Technical Bulletin

No: 712 – Conversion of TR-20 from 520 kHz to 1610 kHz

1. Replace Harmonic Filter Components on Amplifier Board.

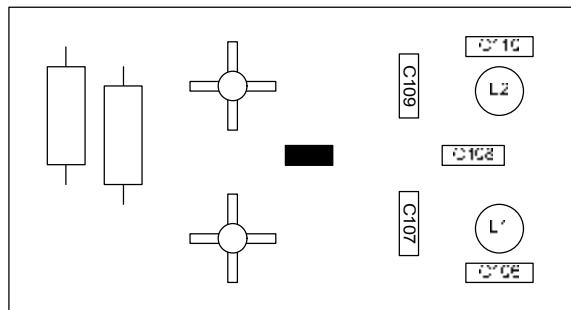
Replace the two inductors and 5 capacitors with the values shown. On the new indicators, scrape away **JUST ENOUGH** varnish to wrap around the turret posts on the PC board. Scraping too much can cause a short to the ground plane! Secure the coils to the PC board with silicone RTV sealant.

LOCATION	ORIGINAL VALUE	NEW VALUE
C106	3600 pF (P/N 2883)	2000 pF (P/N 2890)
C107	1000 pF (P/N 2882)	220 pF (P/N 2891)
C108	5600 pF (P/N 2884)	3300 pF (P/N 2885)
C109	3300 pF (P/N 2885)	750 pF (P/N 2892)
C110	2200 pF (P/N 2886)	1500 pF (P/N 2791)
L1	36 turns (P/N 2876)	23 turns (P/N 2880)
L2	24 turns (P/N 2877)	19 turns (P/N 2881)
